STATE OF DELAWARE
DEPARTMENT OF TRANSPORTATION
800 BAY ROAD
P.O. BOX 778
DOVER, DELAWARE 19903

The enclosed Traffic Impact Study (TIS) review letter for the **7-Eleven - Seaford** (Protocol Tax Parcel 331-05.00-63.00) development has been completed under the responsible charge of a registered professional engineer whose firm is authorized to work in the State of Delaware. They have found the TIS to conform to DelDOT's Development Coordination Manual and other accepted practices and procedures for such studies. DelDOT accepts this letter and concurs with the recommendations. If you have any questions concerning this letter or the enclosed review letter, please contact me at (302) 760-2167.

RE: Agreement No. 1773
Traffic Impact Study Services
Task No. 1A Subtask 19A – 7-11 Seaford

McCormick Taylor has completed its review of the Traffic Impact Study (TIS) for the 7-11 Seaford development prepared by Traffic Planning and Design, Inc. (TPD), dated March 13, 2019. TPD prepared the report in a manner generally consistent with DelDOT's Development Coordination Manual.

COVER SHEET & SKETCH PLAN

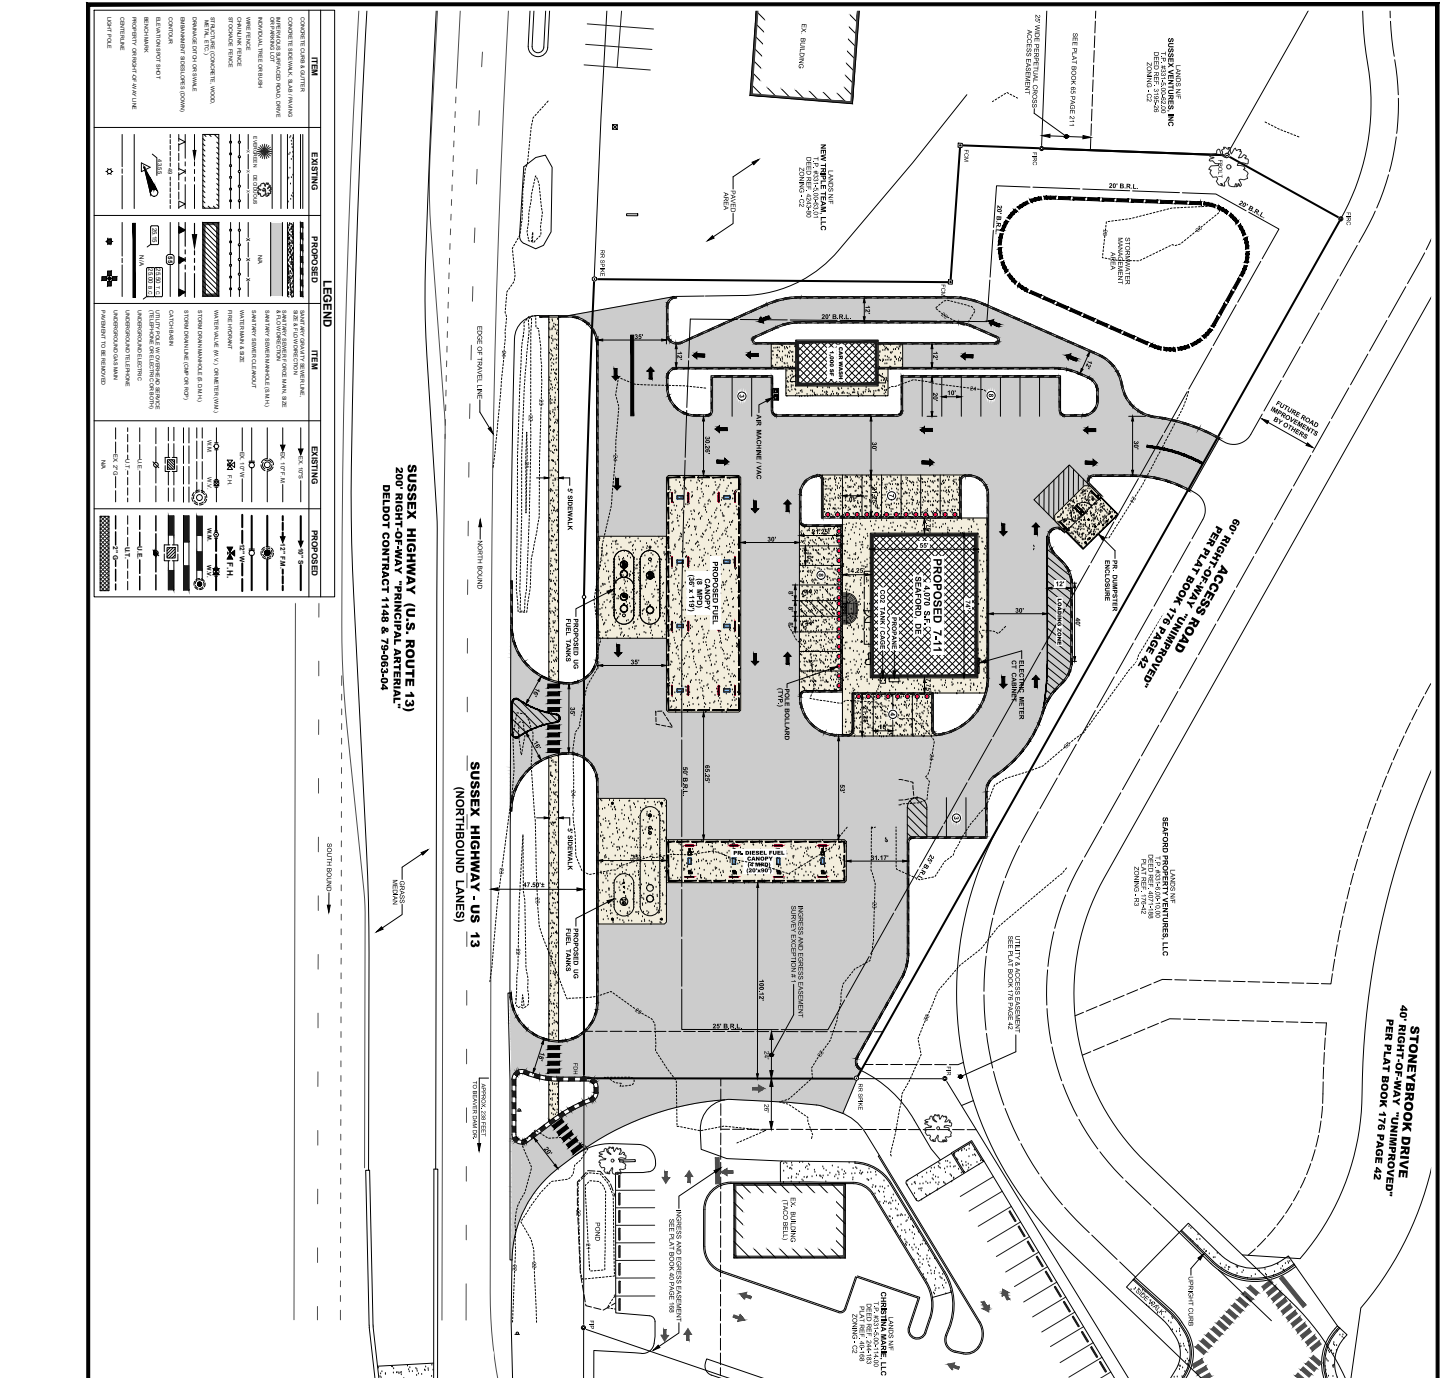
4. The developer should provide a driveway stub for a future connection to Preservation Drive, to be located between the 7-11 building and the stormwater management area similar to that shown on the Cover Sheet and Sketch Plan dated April 17, 2020 (included on page 5 of this letter), except the stub should also include a pedestrian connection out to Preservation Drive. The stub should be labeled on the plan as to its purpose and should be

free of conflicting features such as parking spaces or dumpster pads. Preservation Drive will be extended to meet the stub by others at a date yet to be determined.

The developer should coordinate with DelDOT's Development Coordination Section and the City of Seaford regarding design and construction details for the new driveway stub that would connect 7-11 with the future Preservation Drive.

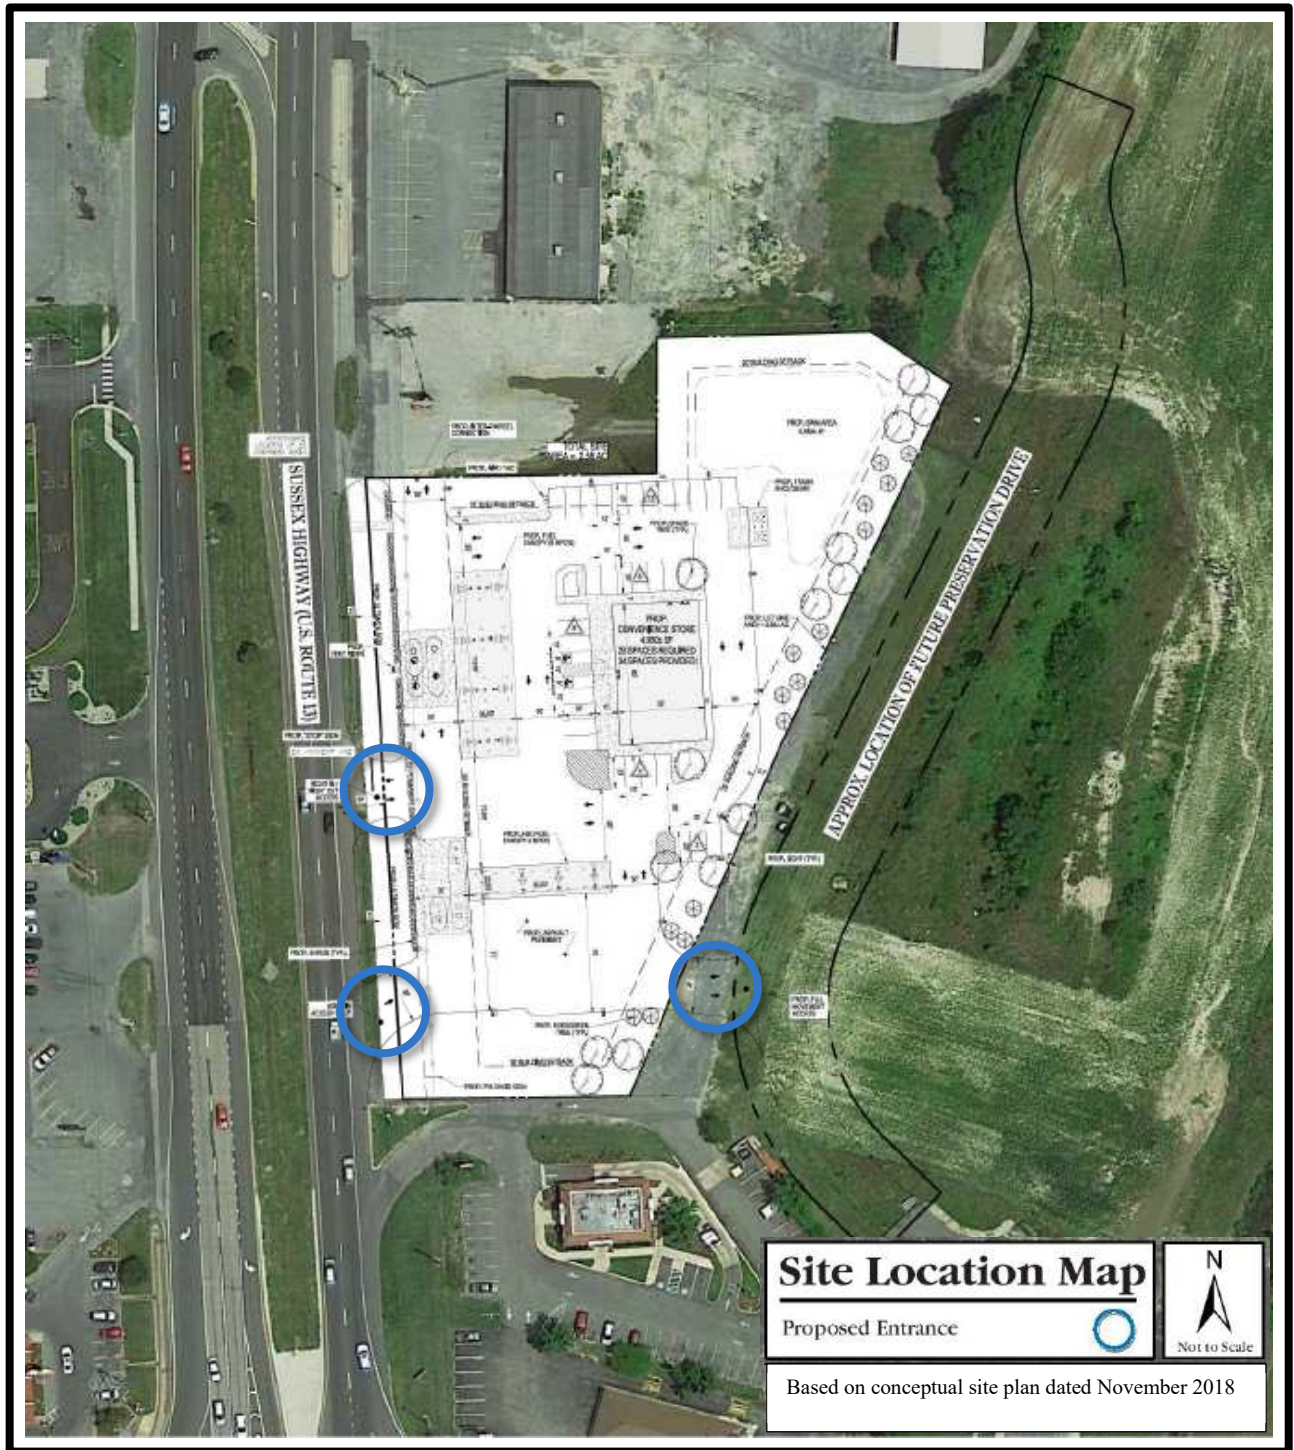
Location: The 7-11 Seaford development is proposed to be located on the east side of US Route 13, north of the intersection of Delaware Route 20 and Beaver Dam Road, in the City of Seaford, Sussex County. A site location map provided in the March 2019 TIS is included on page 9 of this letter, although the proposed access and other site details shown on that plan are now outdated. An updated Sketch Plan dated April 17, 2020 is included on page 5 of this letter.

Proposed access locations: Two direct access points are proposed along US Route 13, with the south access as rights-in only and the north access as rights-in/rights-out. (Note the originally proposed south rights-in only access has since been replaced with a proposed rights-in/rights-out access that combines with the existing rights-in access for Taco Bell to the south). There is an additional interconnection proposed to a planned extension of an existing service road ("Preservation Drive") on the east side of the land.
